# Charge Air Cooler Revision

M-265-001

All CXU, CHU, & GU Models built before May 2007

**Charge Air Cooler Mounting Arrangement (Previous Design Shown on Left)**

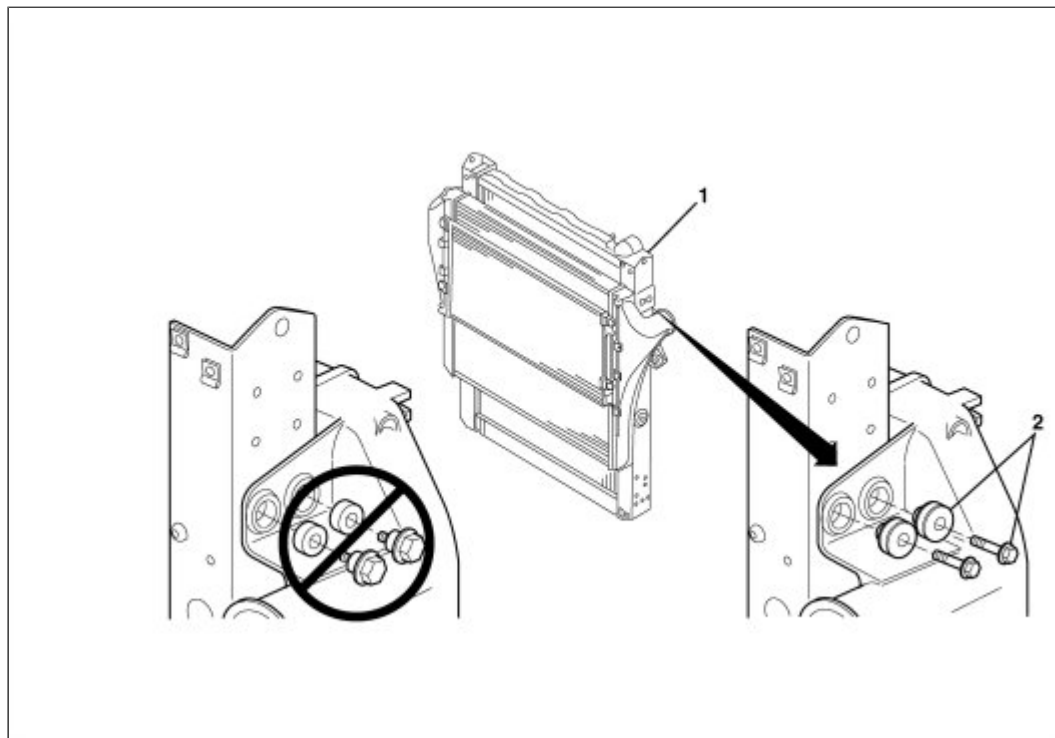
A revised charge air cooler (part Nos. 20956580 and 20956585) was implemented into production on all CXU, CHU and GU model chassis. This revised charge air cooler includes a redesigned upper mounting area, whereby the shoulder bolt and bushing arrangement was changed to sleeved washers and mounting bolts. Should replacement of a charge air cooler on a CXU, CHU and GU model manufactured prior to May 2007 be required, the existing shoulder bolts and bushings must be replaced with the sleeved washers and mounting bolts. An upper mounting hardware kit (part No. 85111312), which contains four sleeved washers and four mounting bolts, is available through the MACK Parts System.

Key	Qty.	Part No.	Description	Replaces
1	1	20956580	Charge air cooler, long	20750095
	1	20956585	Charge air cooler, short	20750102
2	1	85111312	Kit, upper mounting
